Memorandum to the City of Markham Committee of Adjustment

May 19, 2022

File: A/016/22
Address: 1388 Castlemore Avenue – Markham, ON
Applicant: Chitra Pathmanathan
Agent: Varatha Design Associates (Ken Varatha)
Hearing Date: May 25, 2022

DRAWING TITLE: SITE PLAN

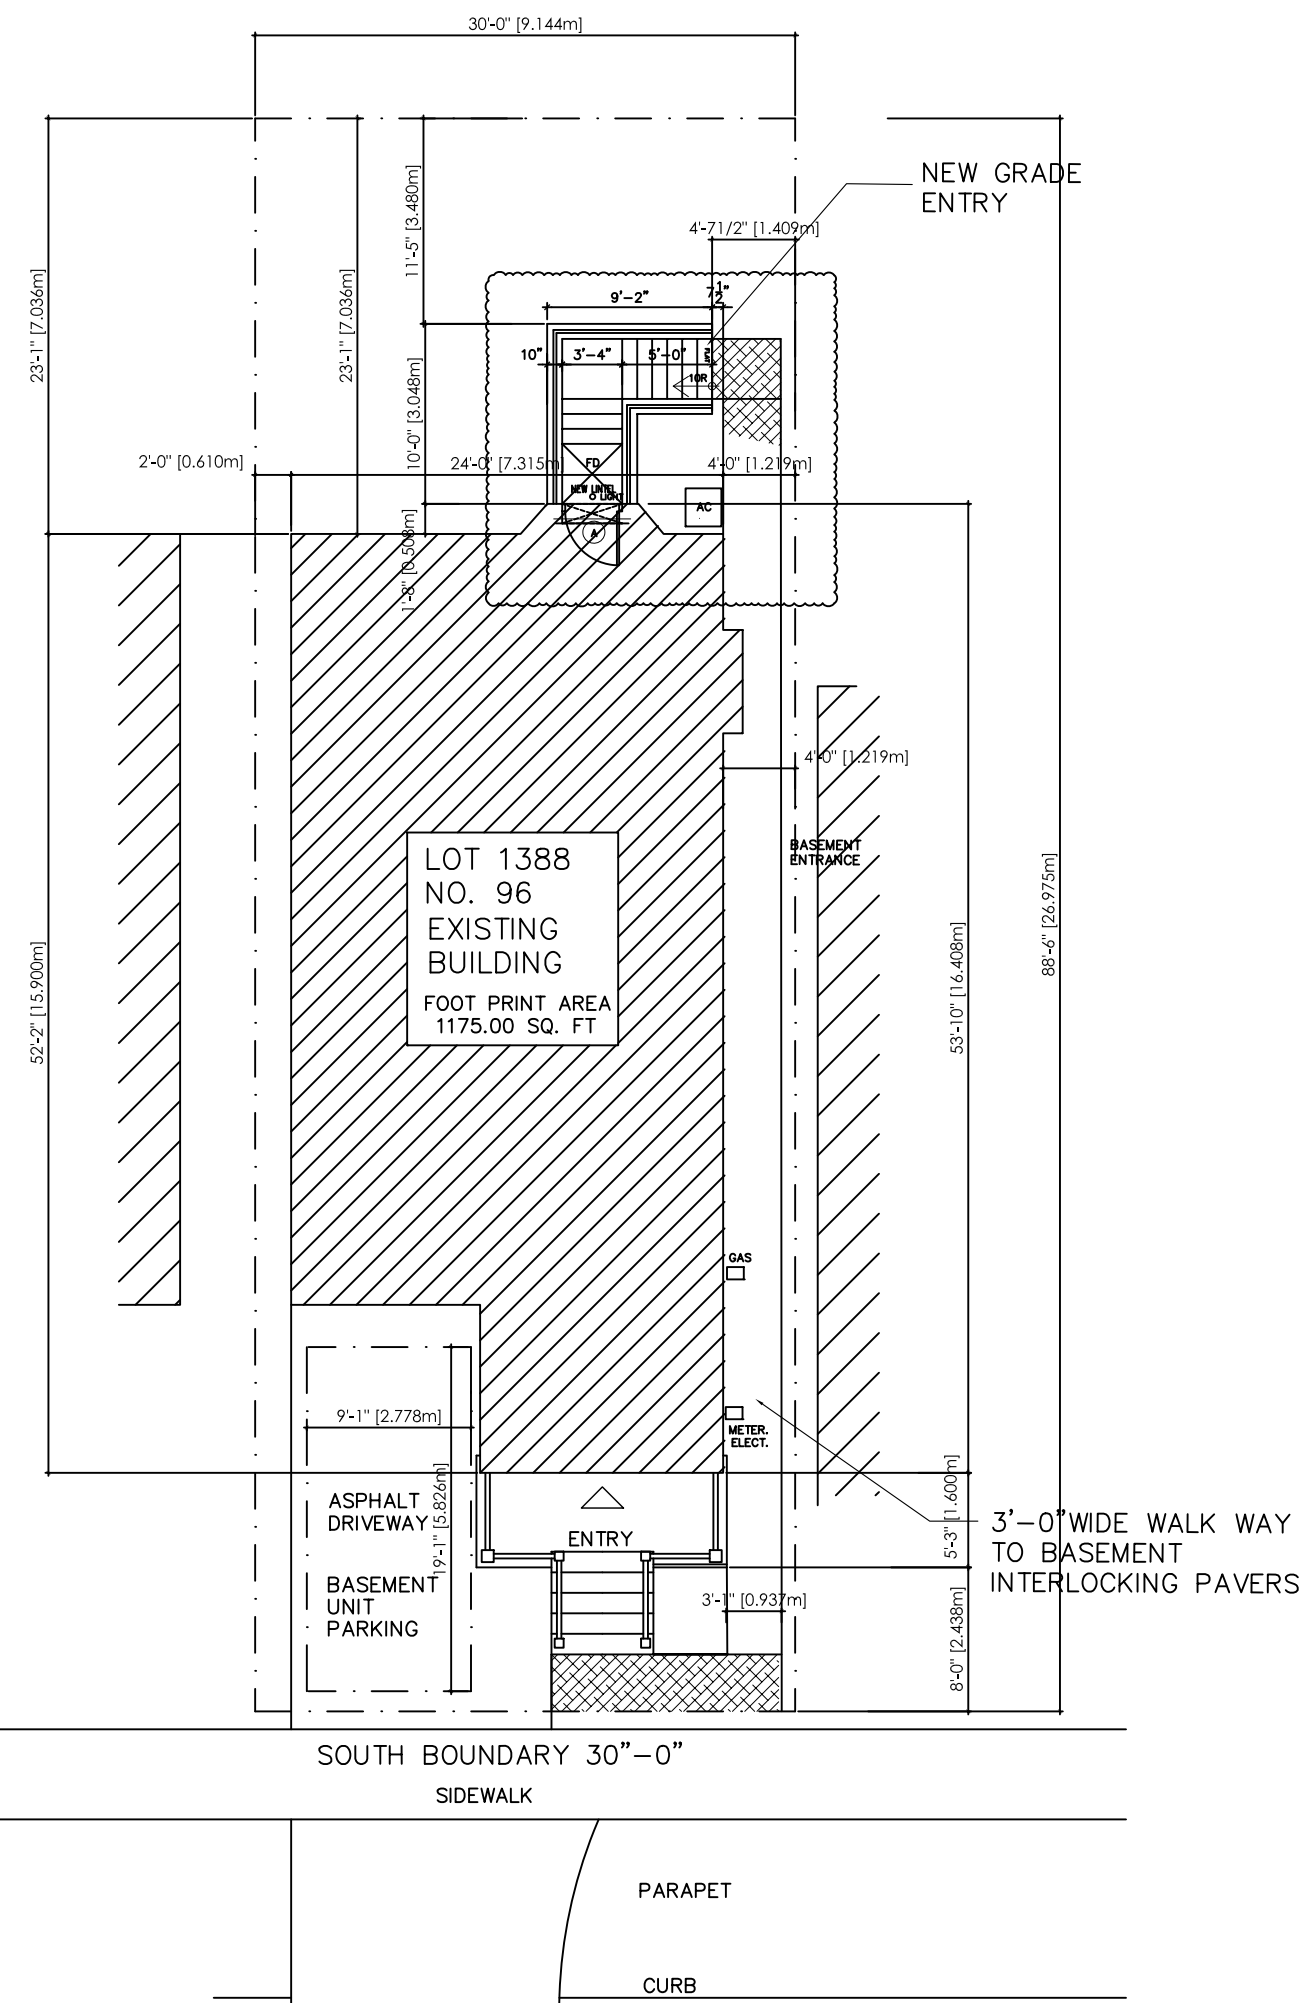
The applicant submitted revised drawings on May 3, 2022, which proposes new walk-up stairs located at the north side (rear) of the dwelling to access the proposed secondary suite (Appendix “B”). While variances to permit a secondary suite and associated parking reduction remain, the applicant proposes to remove the side yard steps, and therefore no longer requires a reduction to the interior side yard setback. Regarding the proposed secondary suite and parking reduction, staff comments from the initial staff report dated April 8, 2022 remain applicable (Appendix “C”).

With respect to the revisions made, the applicant requests a new variance to permit new walk-up stairs to encroach a maximum distance of 3.52 m (11.55 ft) into the required rear yard, whereas the By-law permits stairs and landings that access any part of the main building on the lot not associated with a deck or porch to encroach into the required rear yard a maximum distance of 2.0 m (6.56 ft).

As the walk-up stairs are below grade, staff do not anticipate any adverse impacts to neighbouring properties. Staff consider the alternate access to the additional dwelling unit

an appropriate solution to mitigate drainage concerns, and are of the opinion that the requested variance is appropriate for the lot, and minor in nature.
